Report No. CHAINVALLEY04/01

SUBJECT: Independent Peer Review of Subsidence and Impact Assessment Undertaken by Ditton Geotechnical Services Pty Ltd: Chain Valley to Mannering Colliery Connection Roadways

FIGURE 3. Measured Time Dependent Subsidence Behaviour above Comparable GN Seam Workings (Reproduced Figure 8b from DGS 2014)

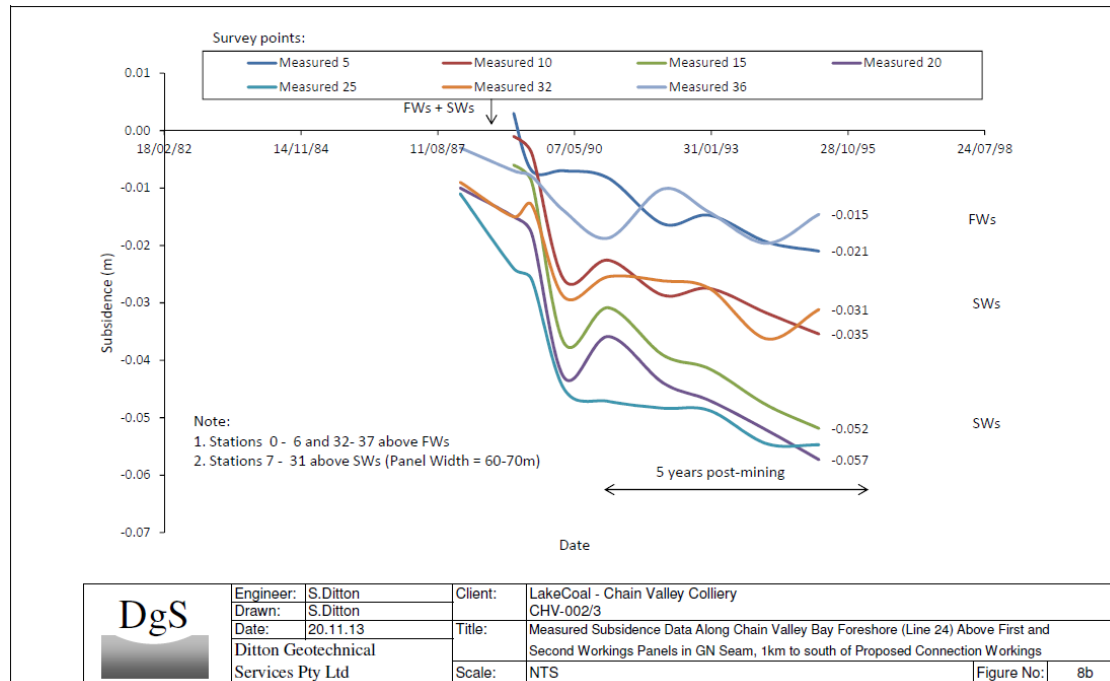
- (iii) A significant effort has been made to provide rational and logical explanation for previous unexpected surface subsidence “events” in the general vicinity, these relating to the time-dependent behaviour of soft floor measures directly beneath Great Northern Seam workings. Offering a credible explanation for measured time-dependent subsidence behaviour (see **Figure 3** as an example) that when it was occurring resulted in significant cause for concern as to long-term outcomes, is a significant contribution to the DGS impact assessment, particularly as it has been linked to a well-established

aspect of claystone stability under vertical loading, namely the exceedance of pre-consolidation pressures resulting in primary and secondary consolidation over time.

FIGURE 4. Predicted Subsidence Isopachs Due to the Formation of the Connection Headings in the Fassifern Seam and Surface Features (Reproduced Figure 18b from DGS 2014)

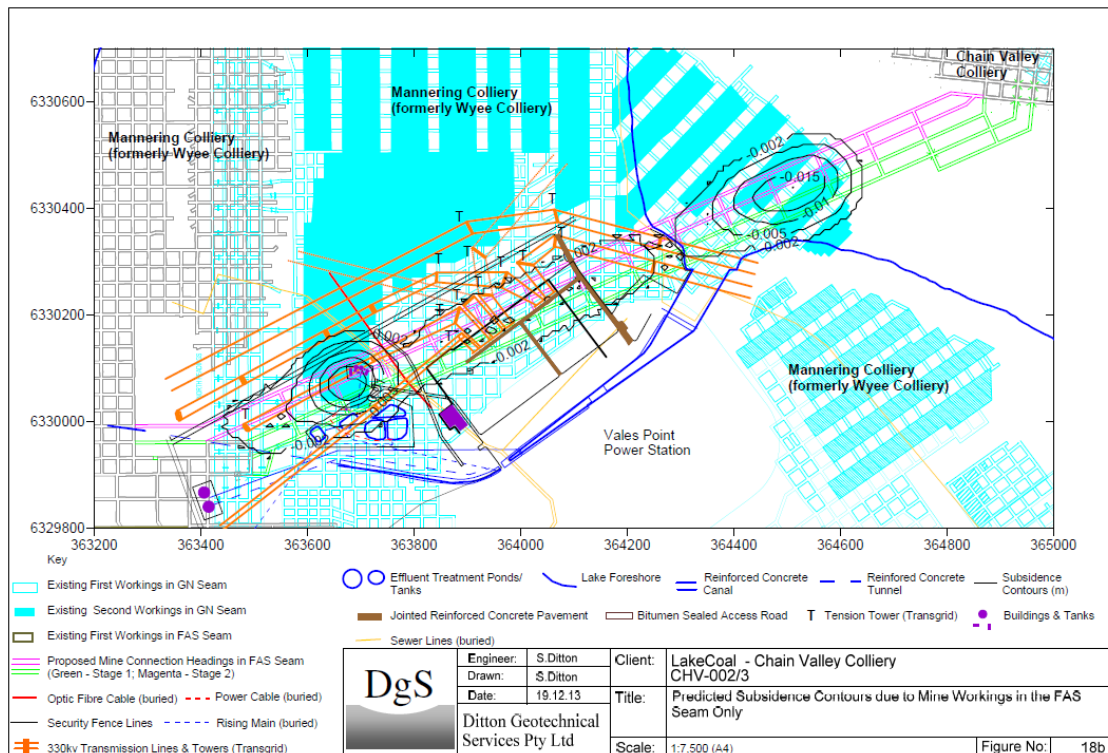
Figure 4 shows isopachs of the increase in surface subsidence as a direct result of forming the proposed connection headings along with the various surface features that are of relevance. This figure along with those detailing tilts, curvatures and strain provide a credible basis for assessing the likely impact on the various defined surface features due to the formation of the Fassifern Seam connection headings.

The areas of pre-existing second workings in the Great Northern Seam are logically where the highest level of additional surface subsidence has been predicted due to the formation of the connection headings. Up to 25 mm of additional vertical lowering is predicted in these areas, albeit that the lake foreshore is limited to in the order of 2 mm of additional lowering due to the Great Northern Seam workings having been restricted to first workings directly under the foreshore.

The TransGrid infrastructure of the Vales Point sub-station and nearby transmission towers (some of which are known to be tension towers) is situated above first workings in the Great Northern Seam such that the predicted increase in vertical subsidence as a result of forming up the proposed connection headings in the Fassifern Seam is 6 mm and less, again noting the conservative assumptions used by DGS when calculating these values. The associated maximum values of curvature, tilt and strain are $< 0.03 \text{ km}^{-1}$, $< 0.2 \text{ mm/m}$ and $< 0.3 \text{ mm/m}$ respectively. **Figure 4** also indicates that the majority of the TransGrid tension towers are located outside the 2 mm additional surface lowering isopachs so will be influenced by $< 2 \text{ mm}$ of vertical lowering due to the proposed mining.

Overall, it is judged that the vertical subsidence predictions provided by **DGS 2014** are at the absolute low end of what can be considered as “meaningful predictions” in that any lower values would almost certainly lead to a conclusion of “zero” subsidence. It is considered that the various predictions as they relate to TransGrid infrastructure can be classified as “imperceptible” levels of increased surface subsidence as it is likely that they will result in no obvious visible changes to surface conditions and may not even be detectable using survey methods (dependent upon local near-surface strata conditions).
